Agenda
City of Springboro Planning Commission Meeting
Wednesday, November 16, 2022, 6:00 p.m.
Council Chambers, City Building, 320 West Central Avenue

Rezoning, Stoneridge Development, southwest corner of East Central Avenue (SR 73) and Red Lion-Five Points Road, Clearview Crossing residential subdivision

Site Plan Review, 800 West Central Avenue (SR 73), proposed Sheetz fuel center, convenience store/restaurant

DRAWING NUMBER:
RL-8224-S1-R1

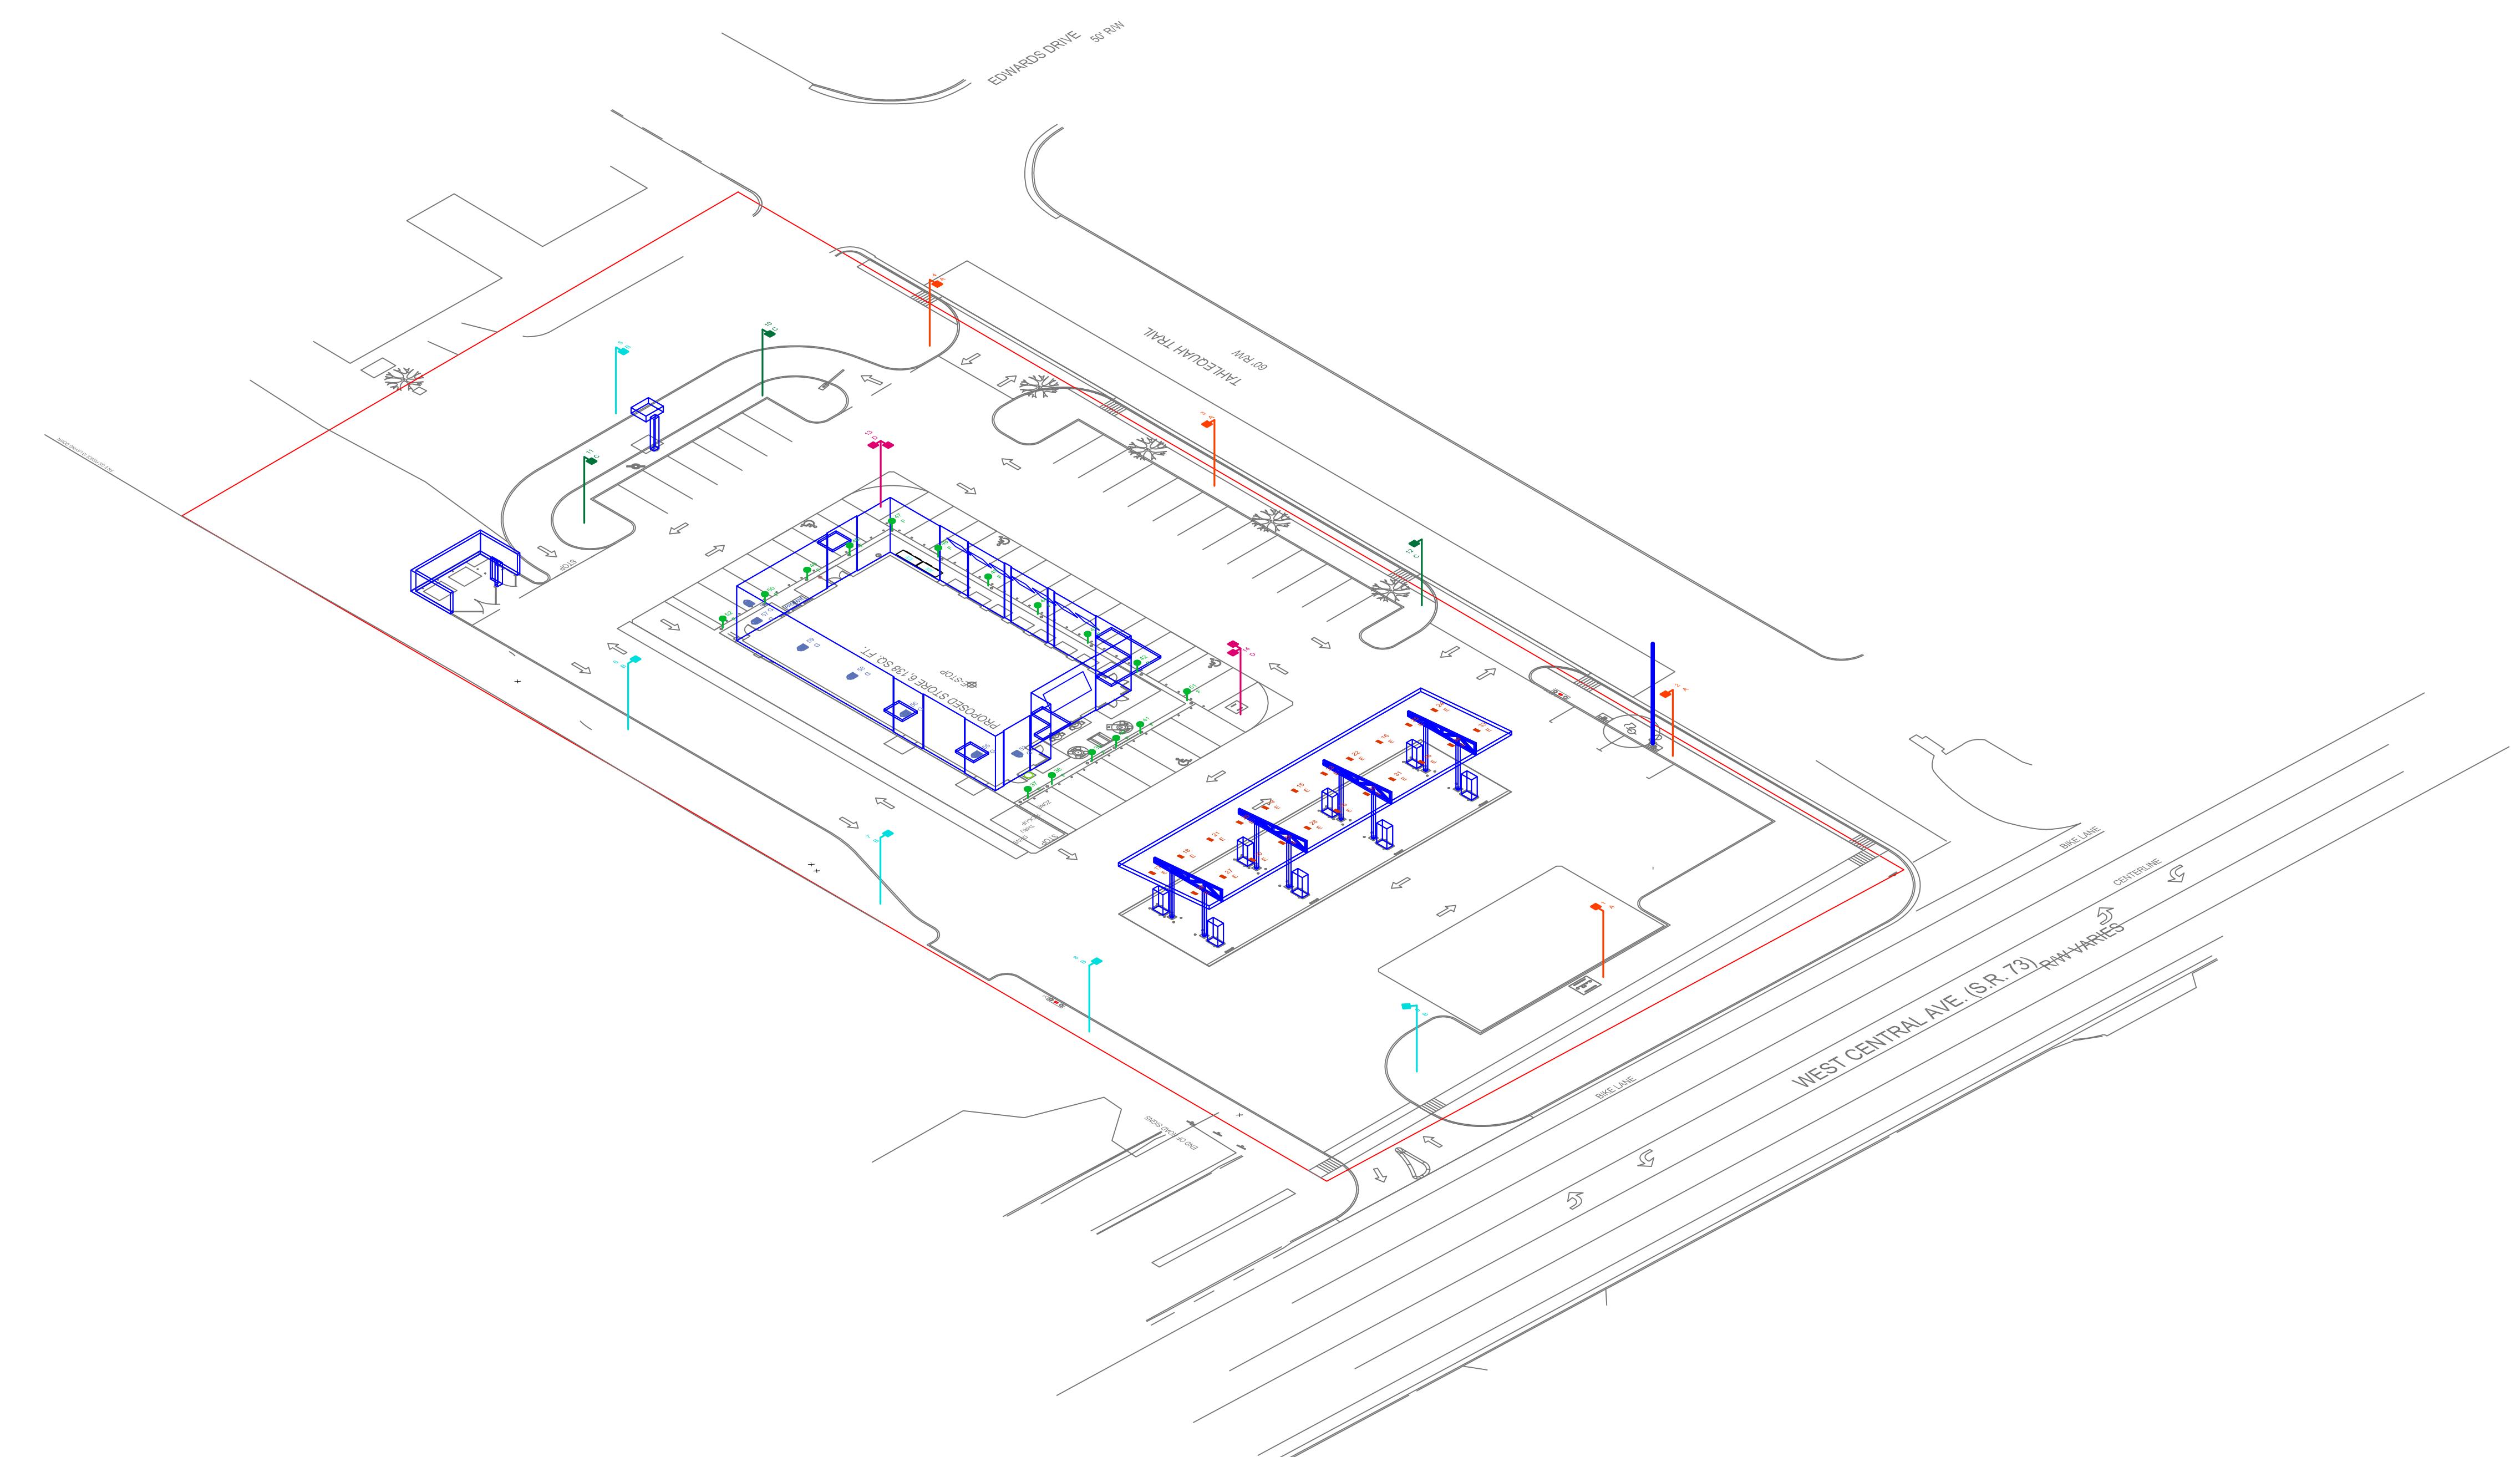
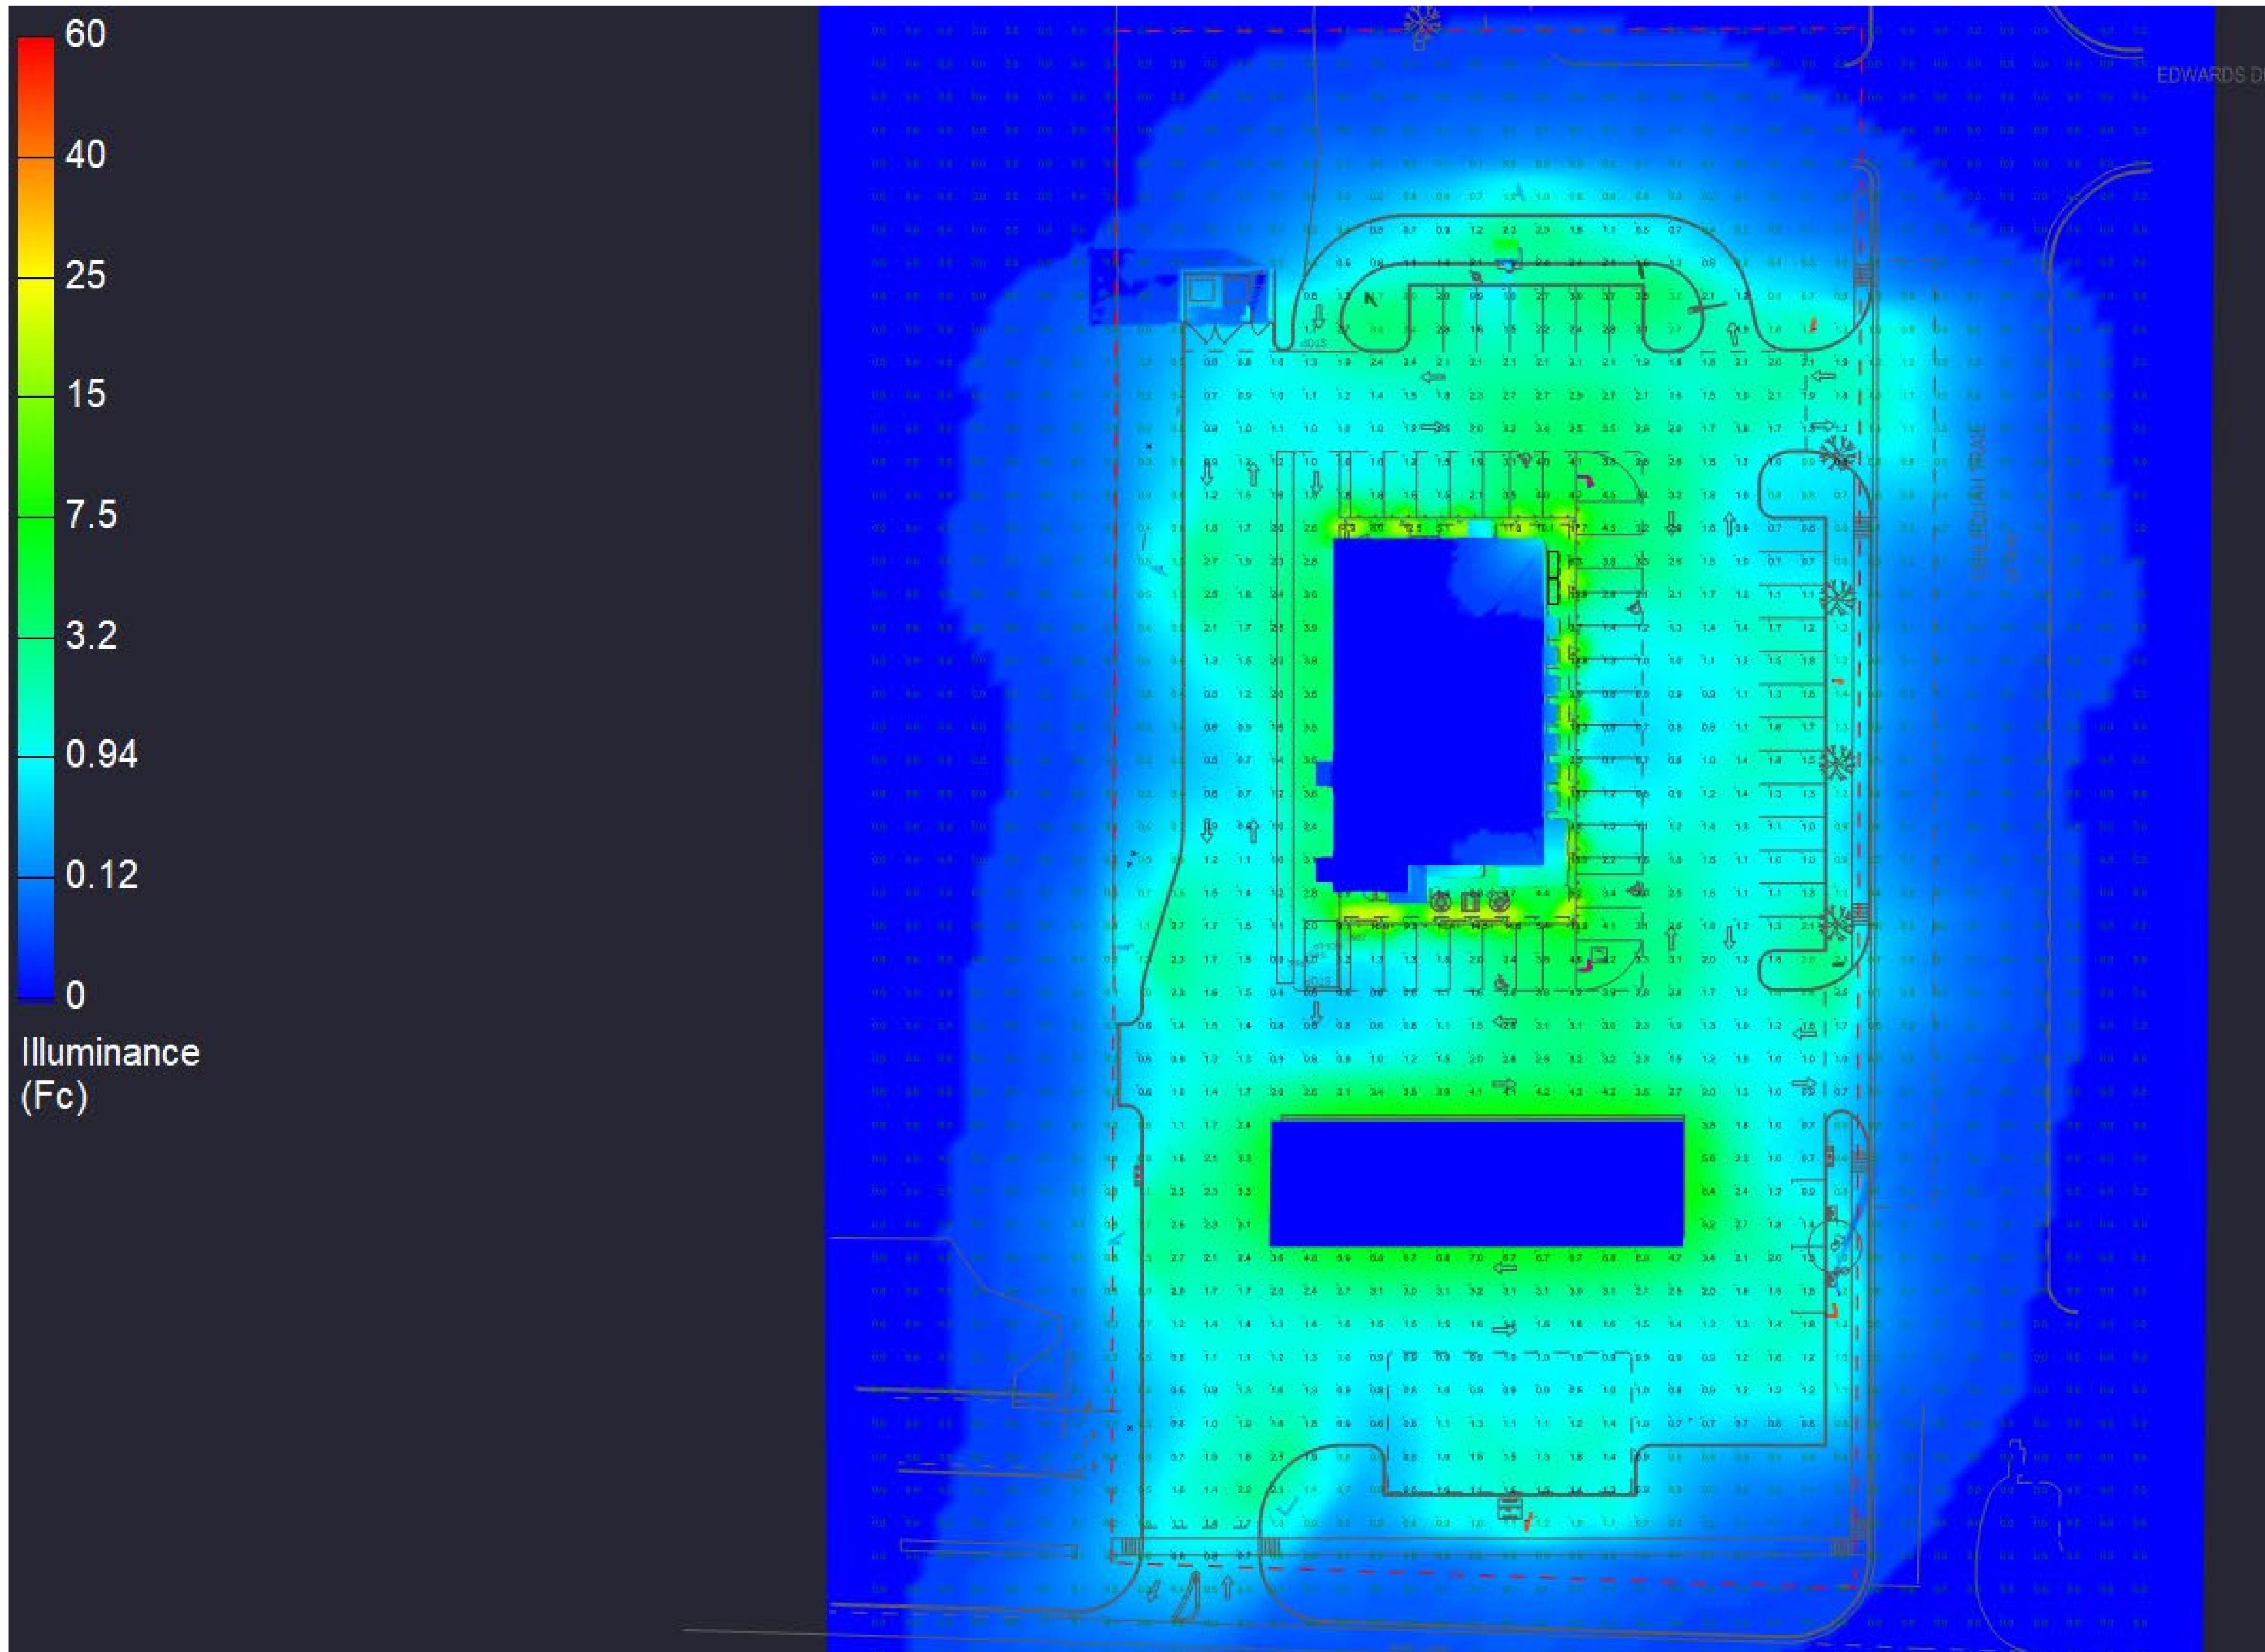
1. For proposed lighting plan, address the following:
 - a. Lighting intensity exceeds maximum 6.0 foot-candle levels adjacent to canopy and adjacent to walkway on perimeter of building on all but west sides.

- b. Verify all lighting is 3500k or less.
 - c. Aside from OSQ lighting proposed, fixtures are not International Dark Sky compliant. While not required, such lighting is consistent with Chapter 1273 standards for color temperature, glare reduction, etc.

- d. Average to maximum (4:1 permitted) and minimum to maximum (10:1) ratio are exceeded on the photometric analysis. Revise plan accordingly.
2. Landscaping plan (sheet L1.0) correctly addresses buffer, parking lot, and site requirements, however coordinate with City staff to identify plantings to comply with requirements in particular site requirement. Landscaping plan may need to be revised to incorporate circulation and access comments. Provide documentation of the manner in which landscaping will screen the fueling center per the provisions of Section 1264.25 of the Planning and Zoning Code as discussed at the October 12th meeting.
